Service Bulletin

Replacement of the alternate air door microswitch with a contactless proximity switch.

GA8 aircraft S/N GA8-00-004 to GA8-05-065.

Document: Service Bulletin SB-GA8-2004-15

Figure 1: Socket wiring detail.

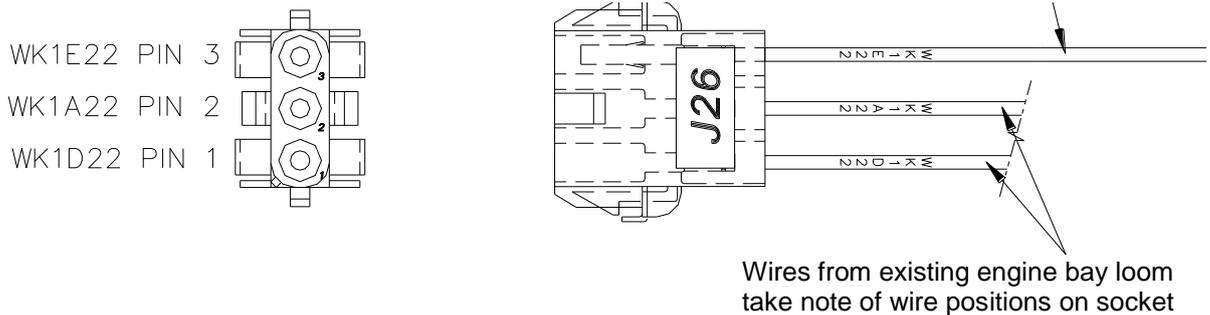
1. The existing microswitch utilizes two wires to function, whilst the new proximity switch requires 3 wires to function. The additional wire is routed to the stall warning breaker.
2. The existing 2 pin socket (J26) must be replaced with a 3 pin socket (also labeled J26) This is accomplished by removing the existing pins from the 2 pin socket and placing them in the 3 pin socket as shown below. Ensure that each wire is inserted into the correct position on the socket as indicated in the figure below.

Figure 4 – Final wire installation.

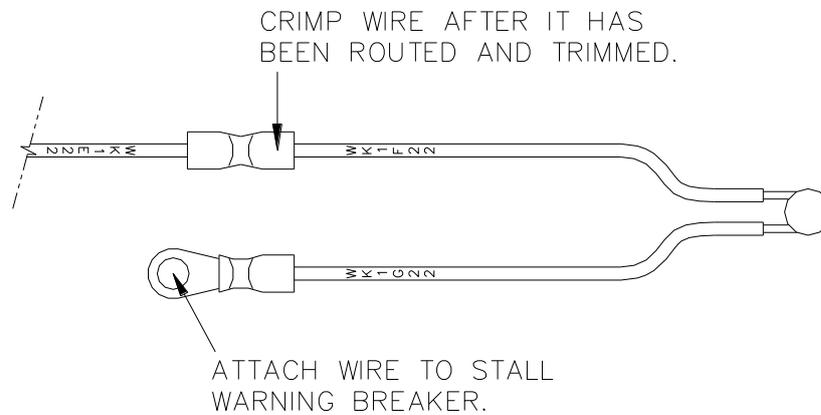
3. Remove LH crew seat, and floor covering to expose the under floor circuit breaker panel.
4. Remove the required panels to route wire WK1E22 through the firewall and alongside the existing wire loom, to the under floor circuit breaker panel.

5. Ensure that all wiring is secured with cable ties, and that the wire bundle that protrudes through the firewall is sealed using PR.
6. Attach wire WK1C22 to the stall warning breaker load terminal. Wire WK1E22 is supplied longer than required, trim off excess wire, allowing sufficient length to join to wire WK1F22 using the supplied crimp connector.

Figure 4: Door return spring bracket clearance.

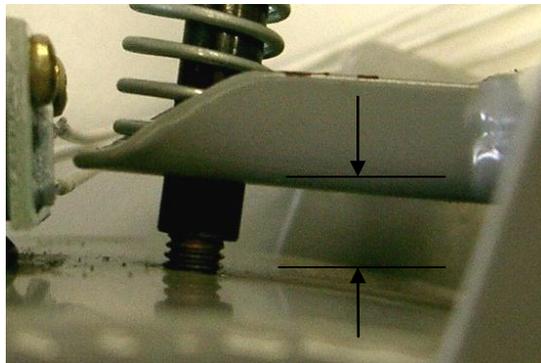
1. Remove door return spring assembly.
2. Remove and discard existing microswitch and bracket.
3. Ensure that there is at least a 0.25" gap as illustrated in the photograph below.

4. Replace door return spring assembly & lockwire in place.

Figure 5: Door return spring bracket, with microswitch assembly removed.

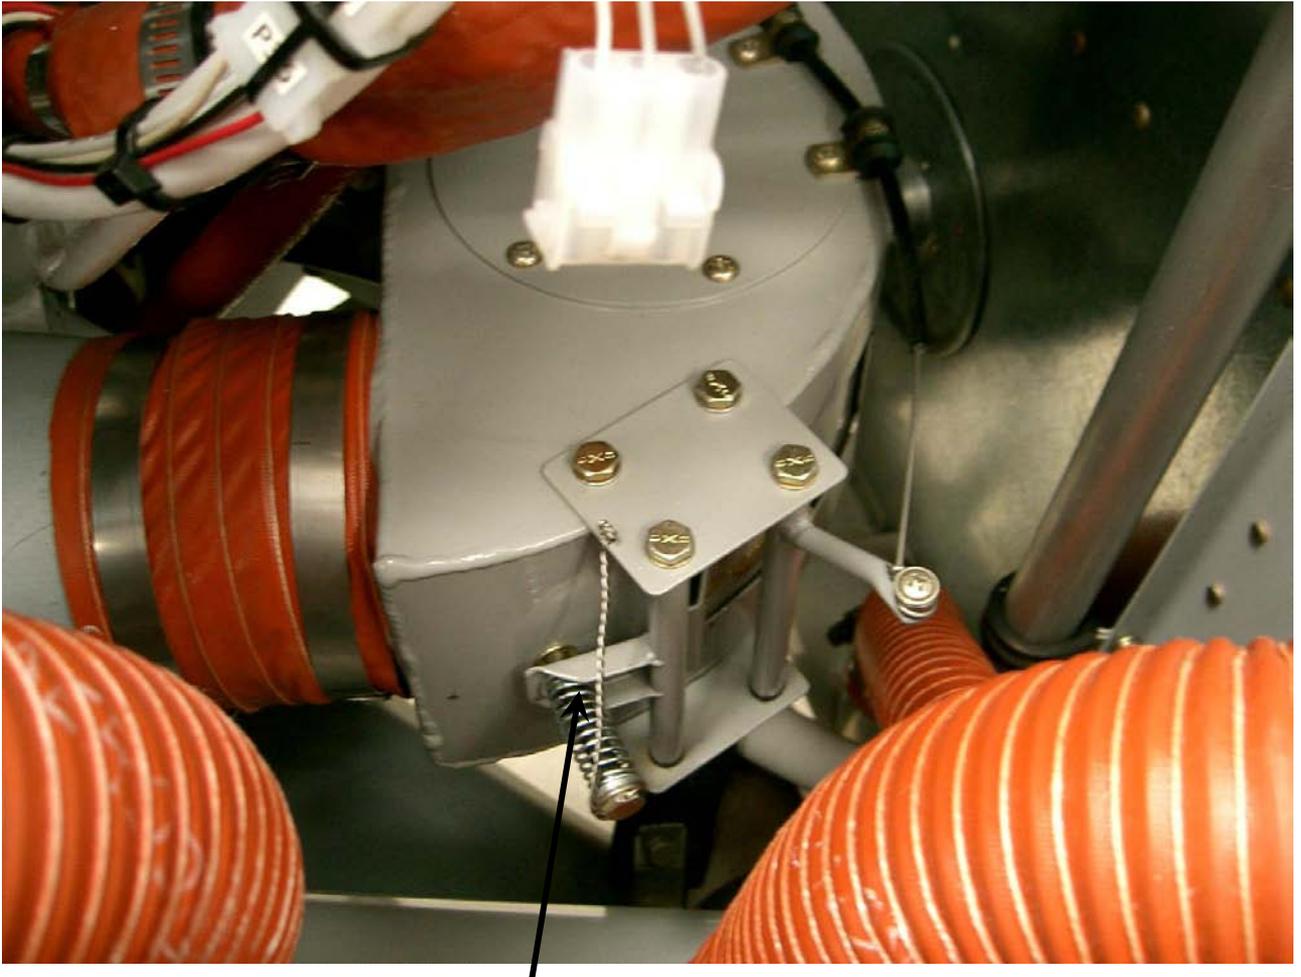
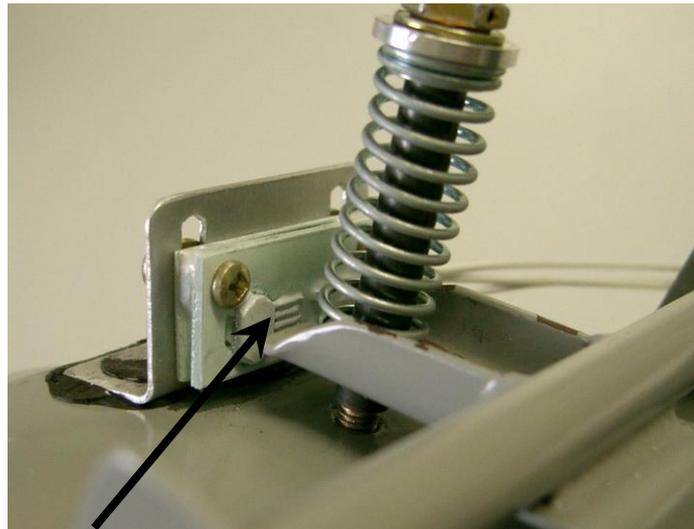
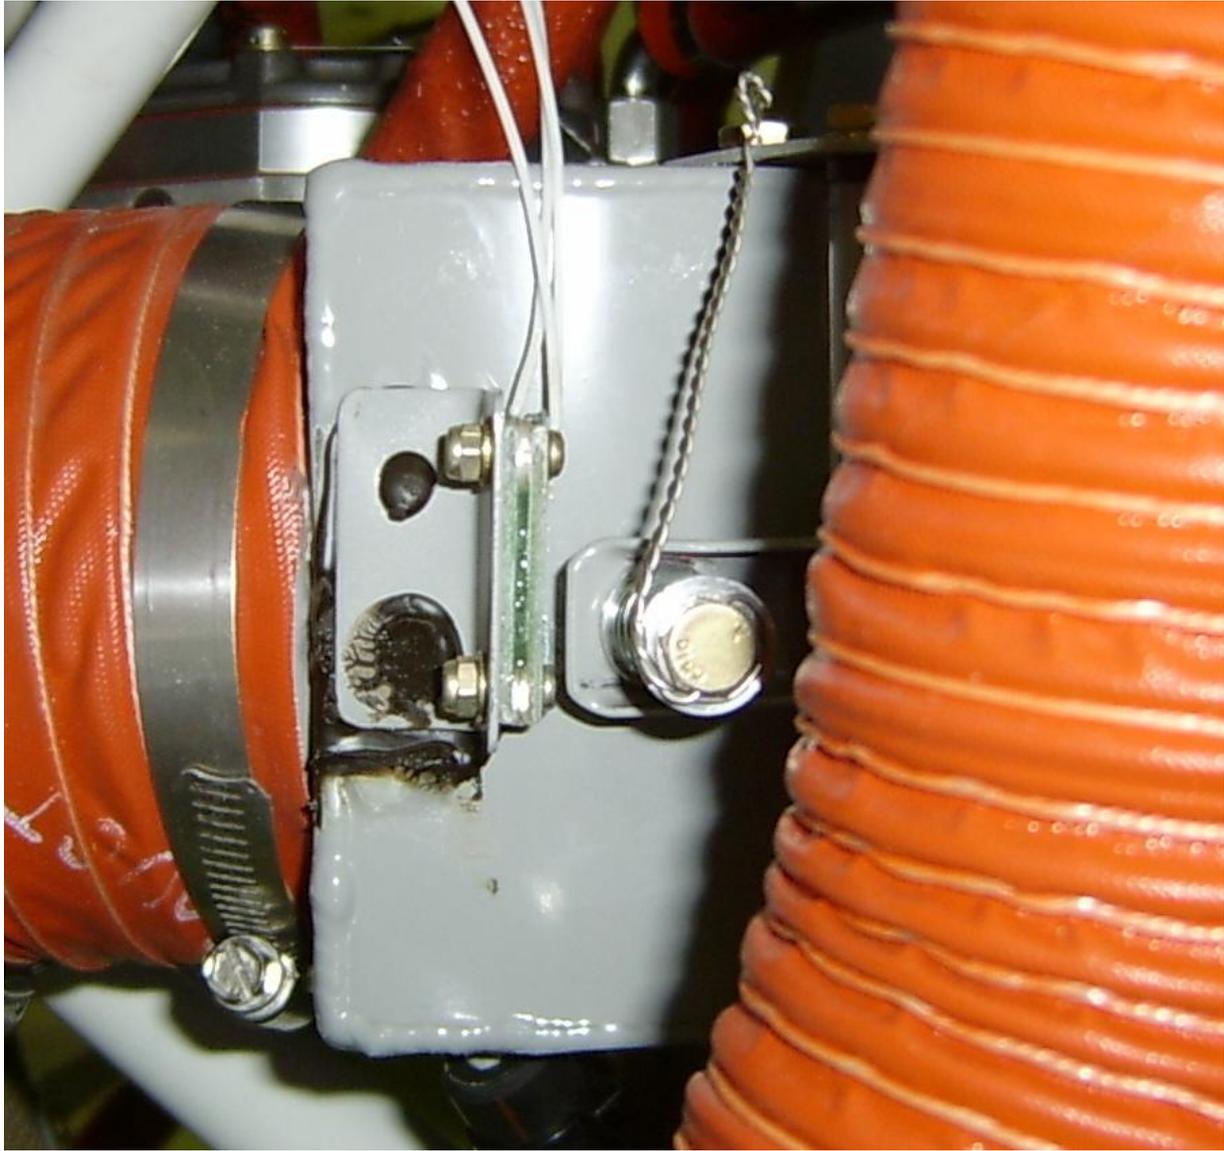
1. Using the photographs as a guide (figures 6 & 7), locate the proximity switch as close to the door return spring bracket as possible ensuring that the operation of the door does not bind on the proximity switch.
2. Typically most installations can utilize a gap of 0.050" (1.27mm) gap between the proximity switch sensor and the door return spring bracket.
3. Using sandpaper, roughen surfaces to be bonded. Apply PR to the proximity switch bracket and position in place on the airbox. Ensure that operation of the air box door maintains a minimum clearance between the door return spring bracket and the proximity switch.
4. Clamp the switch in place and check operation of the ALT AIR warning light with actuation of the alternate air door.

Ensure sensor element is placed in front of metal portion of the door return spring bracket

Figure 7: Switch bracket installation.

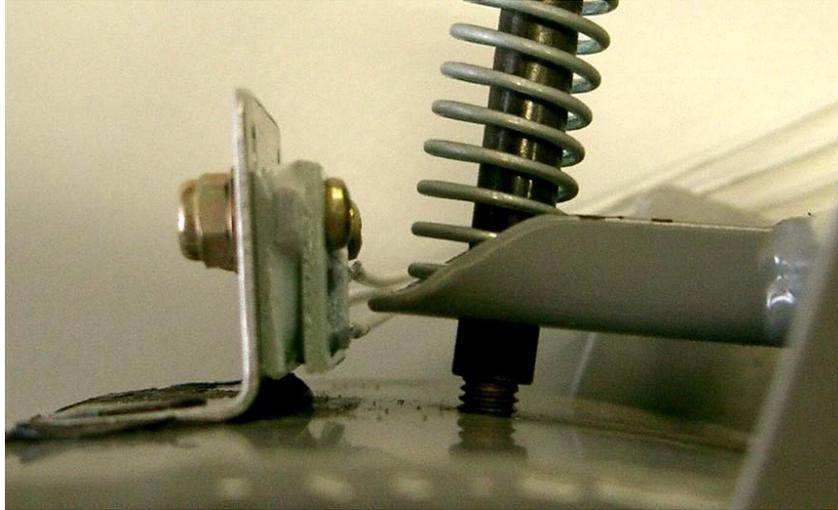
5. After the PR has cured, the sensor position on the bracket can be adjusted such that the ALT AIR warning light illuminates when the alternate air door is open approximately no more than 0.12" (3mm) when measured at the far end of the door from the proximity switch. Tighten adjustment screws, and recheck the operation of the warning light.
